# Access Compliance Report

## Public Rights-of-Way

### (Curb Ramps)

Intersection ID: 11841	Main Street: E_18TH_ST	Cross Street: HARRILL_ST	Location: S
ADA ID: A8DF5248EE3A	Ramp Type: PerpDiag	Initial Pass/Fail: Fail	Overall Compliance: No
		Severity Score: 35

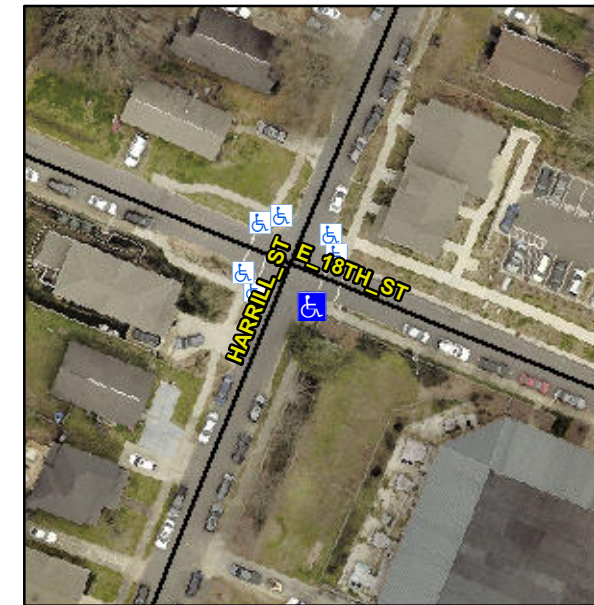
**Not Found, R304.5.1**

Compliance	Description	Data	Compliance	Description	Data
N/A	Ramp Length (in)	74.0	Yes	Ramp Slope (%)	6.3
No	Ramp Width (in)	24.0	Yes	Ramp XSlope (%)	0.9
N/A	Flare Type LT	N/A	N/A	Flare Type RT	N/A
N/A	Flare Slope LT (%)	N/A	N/A	Flare Slope RT (%)	N/A
N/A	Flare Traversable LT?	N/A	N/A	Flare Traversable RT?	N/A
N/A	Landing Length (in)	N/A	N/A	DWS Provided?	N/A
N/A	Landing Width (in)	N/A	N/A	DWS Contrast?	N/A
N/A	Landing Slope (%)	N/A	N/A	DWS Length (in)	N/A
N/A	Landing X Slope (%)	N/A	N/A	DWS Full Width?	N/A
N/A	Landing Curb? (Y/N)	N/A	N/A	DWS Offset (in)	N/A
N/A	Shared Landing?	N/A			
N/A	Gutter Ponding?	N/A	N/A	Gutter Slope (%)	N/A
N/A	Gutter Lip Ht (in)	N/A	N/A	Gutter X Slope (%)	N/A
N/A	Painted X Walk1?	No	N/A	Painted X Walk2?	No
	X Walk 1 Direction	To NE		X Walk 2 Direction	To NW
N/A	X Walk 1 Width (in)	N/A	N/A	X Walk 2 Width (in)	N/A
	X Walk 1 Slope (%)	4.8		X Walk 2 Slope (%)	2.1
	X Walk 1 X Slope (%)	0.4		X Walk 2 X Slope (%)	2.4

**Remove & Replace Curb Ramp With Two New Directional Ramps or Equivalent.**
